Re: Surrey Hill
Rezoning & Outline Development Plan (ODP) proposal for a 12.16 acre
site located at the northwest corner of the intersection of 27½ Rd.
and Cortland Avenue (F3/4 Rd.)

REVIEW SHEET SUMMARY

FILE NO. 18-82 DUE DATE 3/12/82
 ACTIVITY Rezone & ODP, RSF-4 to PR-10, Surrey Hill
 PHASE _____ ACRES _____
 LOCATION NW corner of 27.5 Rd. and F.75 Rd. section line
 PETITIONER Natalie Stettner & Charles Reicks
 PETITIONER ADDRESS 743 Horizon Court
 ENGINEER TCB, Downing/Leach & Assoc.

Response to Review Sheet Summary,
Surrey Hill Rezone Application,
File No. 18-82

Surrey Hill

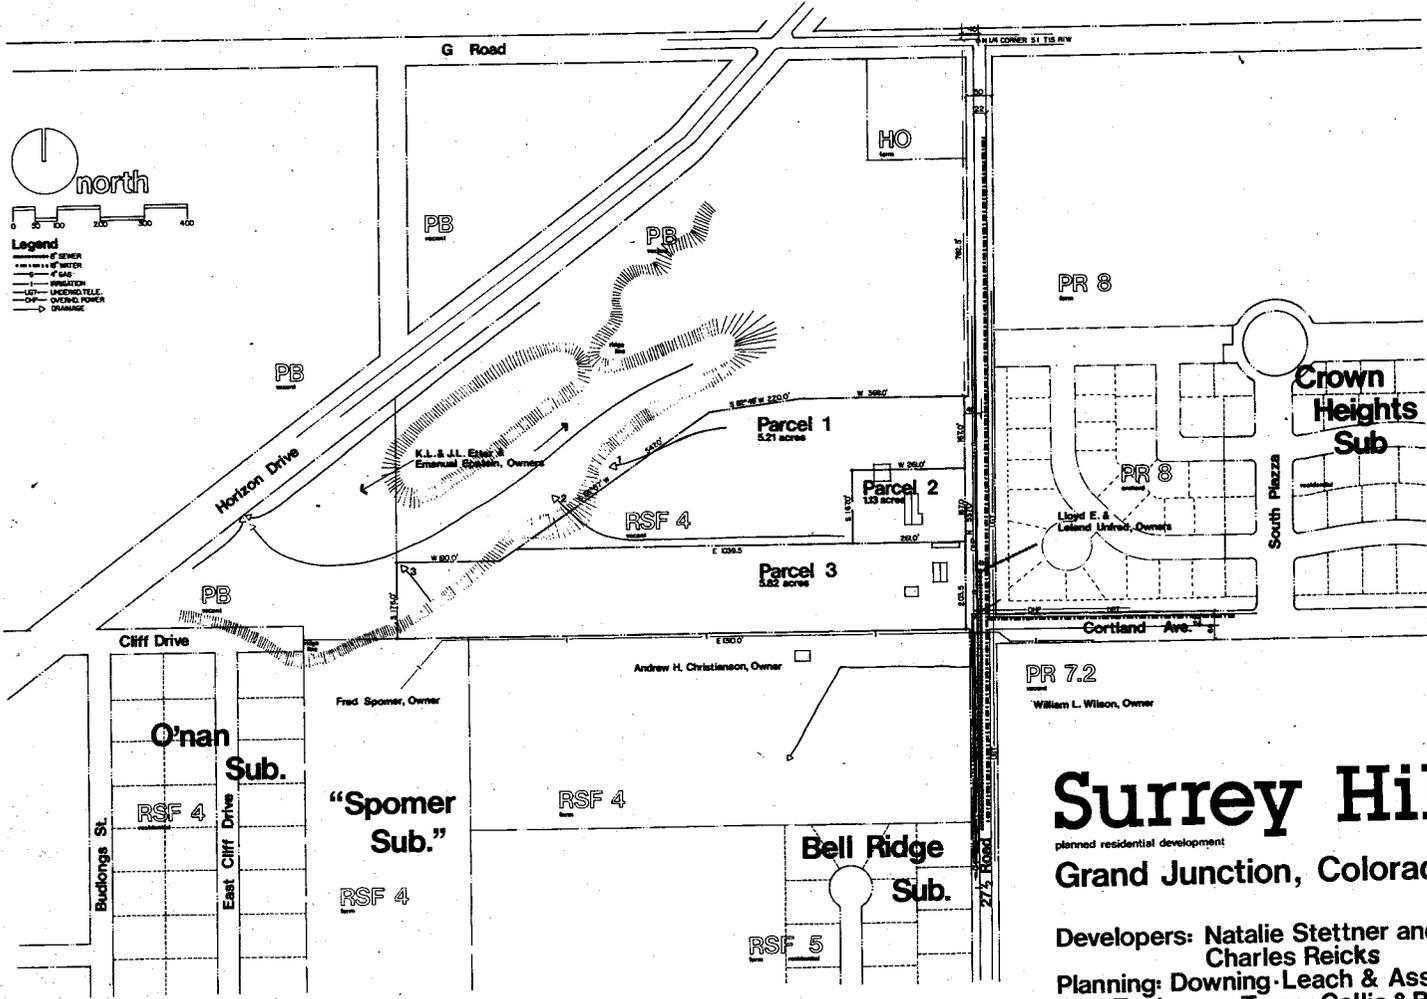
3/9/82	Mountain Bell	No request at this time. We will require esmts when prel. plats come through.
3/9/82	Ute Water Dist.	No objection. Correction - concerning existing 18" water main. It does not exist in 27 1/2 Road, South of Cortland Ave. Master metering for multi-family units is 80% of the then standard tap fee for each unit. Individual metering for each unit would be 100% of the then standard tap fee for each unit. Policies & fees in effect at the time of application will apply.

<u>DATE REC.</u>	<u>AGENCY</u>	<u>COMMENTS</u>
3/11/82	City Fire Dept.	This office has no objection to this rezone. Additional plans must be submitted showing proposed water line, fire hydrant placement. This development will require a minimum 8 inch looped line with fire hydrant placement every 300 ft. Possible on site fire hydrants may be required. Please submit plans site, size, construction type etc. to allow for fire flow computation.
3/12/82	Transportation Eng.	Areas "A", "B", and "C" appear to have only a single access point to the main road system. There should be at least two. The "emergency access" points should be full access points. What is the relationship of the north access point onto 27 1/2 Rd. to the Crown Heights entrance?
3/12/82	City Engineer	I am not aware of the "plan" to extend 15th Street south from Horizon Drive. Cortland Avenue should be dedicated to match and align with the right of way east of 27 1/2 Road. The existing irrigation drain near the south boundary will have to be accommodated. 27 1/2 Road should be dedicated to 33 ft. 1/2 right of way and power of attorney granted. Cortland should be improved by Surrey Hill to a minimum of 22 ft mat with curb, gutter and sidewalk on north side. I assume the streets shown will be as per city standards. Any sanitary sewers not located in dedicated streets must be in 20 ft. wide easements with vehicular access to all manholes. It appears from comments on page 4 of the report that off-site improvements may be required for sanitary sewer service. All required offsite sanitary sewer extensions including easements should be by the petitioner. It appears from the drainage layout and comments on page 5 of the report that storm runoff may have to be routed across the property to the north to outlet into Horizon Drive. Any offsite improvements including easements should be by the petitioner.

3/15/82	G.V. Irrigation	This review sheet will be submitted to the Planning Dept. early March 15, 1982, technically late for consideration, but in any event consider this statement as written notice of the fact that the Grand Valley Water Users Assoc. has had an irrigation lateral situated at or near most of the south boundary of the subject property with associated operating and maintenance right of way for more than 60 years. Such lateral continues to serve many water uses and its operating and maint. right of way will continue to be needed and required. In the event modifications to such lateral or its facilities are proposed due to development or any reason, all such modifications will be subject to approval by the Grand Valley Water Users Assoc.
3/16/82	Public Service Kati	
3/16/82	City Utilities Kati	
3/17/82	Staff Comments	This proposal is not in compliance with the adopted airport overlay (Sec. 5-11) which states 4 units/acre is the max density allowed for new development within the adopted critical zone. Since this proposal does lie within the established critical zone, all review agencies recommend a density of 4 units per acre max. Based on this recommendation, the ODP should be denied. A rezone request of PR-4 would be acceptable. It is currently zoned RSF-4 and this would allow a Planned Development of 4 units per acre with no change in overall density. We will not review the ODP until its resubmittal.

The correction regarding the existing 18" water main in 27½ Road is acknowledged and will be reflected in subsequent submittals. Multi-family units will be metered using master metering arrangements under this proposal.

Proposed water lines and fire hydrant placements will be shown in the preliminary plan submittal for approval prior to final plan submittal. All guidelines and requirements of the City Fire Department will be met in subsequent submittals for this site by this petitioner.

The existing irrigation lines near the south boundary will be accommodated and their proposed design shown in the preliminary plan submittal. Please read the response to Grand Valley Water Users Association Comments.

Any and all modifications to the irrigation lateral located at or near the south boundary of the site will be shown in the preliminary plan submittal for the approval by the Grand Valley Water Users Association prior to the final planning approval.
